NUMBER: 23-016-19

Battery Acid Leaking on Transmission Pan

This bulletin involves replacing the battery tray drain pipe, adding a battery vent pipe, battery vent cap and clamps.

RAM ProMaster City

Fig. 3
Clip and New Battery Tray Vent Pipe

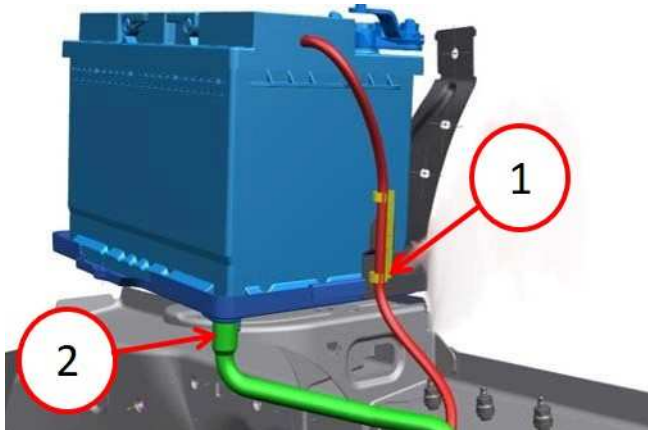
7. Install new battery tray drain pipe **P/N 68417800AA** on the battery tray (Fig. 3) .

8. Install clip **P/N 68476190AA** (Fig. 4) on the battery tray bracket (Fig. 3) .

9. Fasten the battery vent pipe **P/N 68476284AA** on clip **P/N 68476190AA** (Fig. 3) .
10. Install the battery strap and fuse junction box. Refer to the detailed service procedures available in DealerCONNECT/Service Library under: Service Info>08 - Electrical/8F - Engine Systems/Battery System/Battery/Installation.

- 1 - P/N 68476190AA Clip
 - 2 - P/N 68417800AA Battery Tray Drain Pipe
-

Fig. 5
Clamp on Body Hole

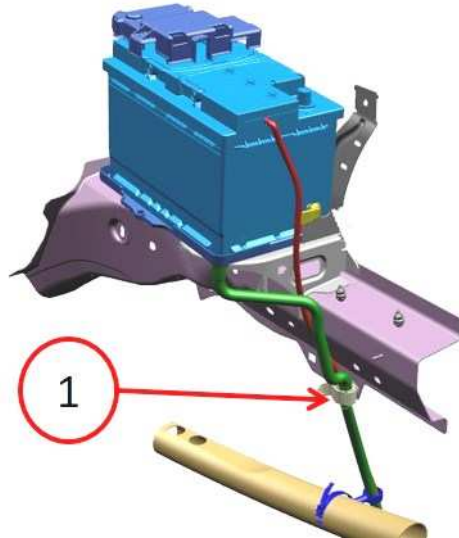
13. Install clamp **P/N 68163243AA** into the body hole (Fig. 5) near the transmission.

1 - P/N 68163243AA Clamp Installed on Body Hole

Fig. 8
Clamp on Radiator Support Beam

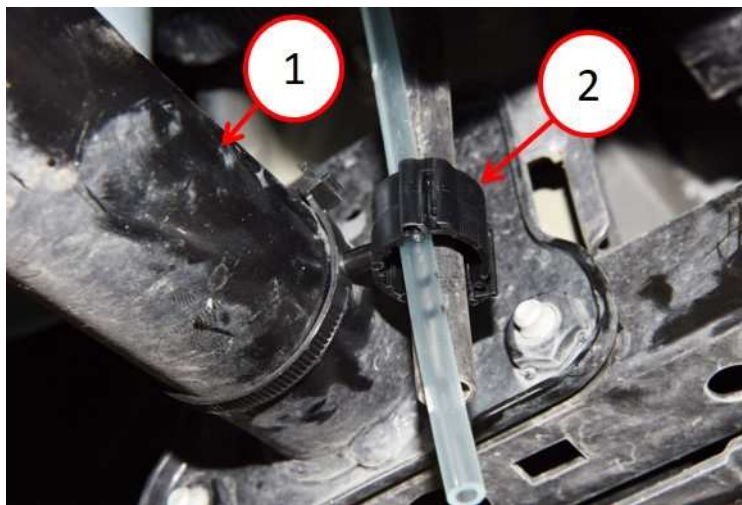
16. Secure the band from clamp **P/N 68461928AA** to the round cradle and radiator support beam (Fig. 8) .

- 1 - P/N 68461928AA Banded Clamp On Pipe
2 - Support Beam
-

Fig. 15
New Battery Vent Pipe Routing and Clamps

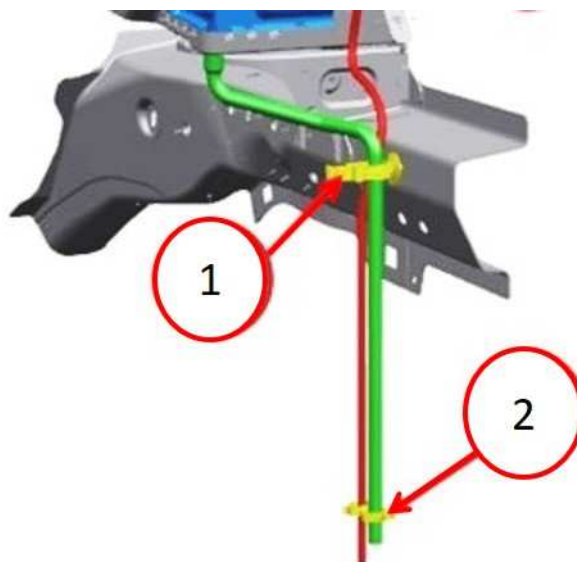
8. Position both pipes downward pointing to the ground (Fig. 15) .

- 1 - P/N 68470618AA Clamp
- 2 - P/N 68112893AA Clamp

Fig. 17
P/N 68112893AA Clamp Measurement Locations

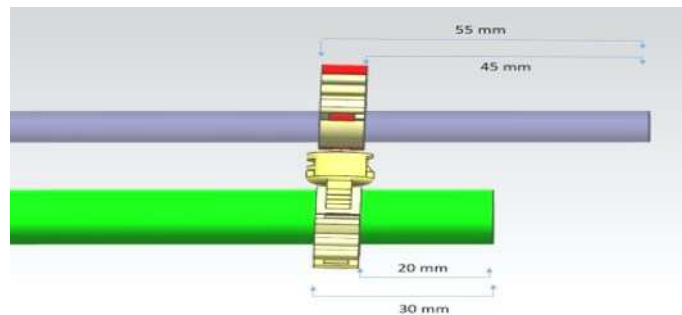
11. Install **P/N 68112893AA** clamp (Fig. 16) on both pipes between 20 - 30 mm (.78 - 1.18 in.) on the tray drain pipe and between 45 - 55 mm (1.77 - 2.16 in.) from the end of the battery drain pipe (Fig. 17) and (Fig. 18) .
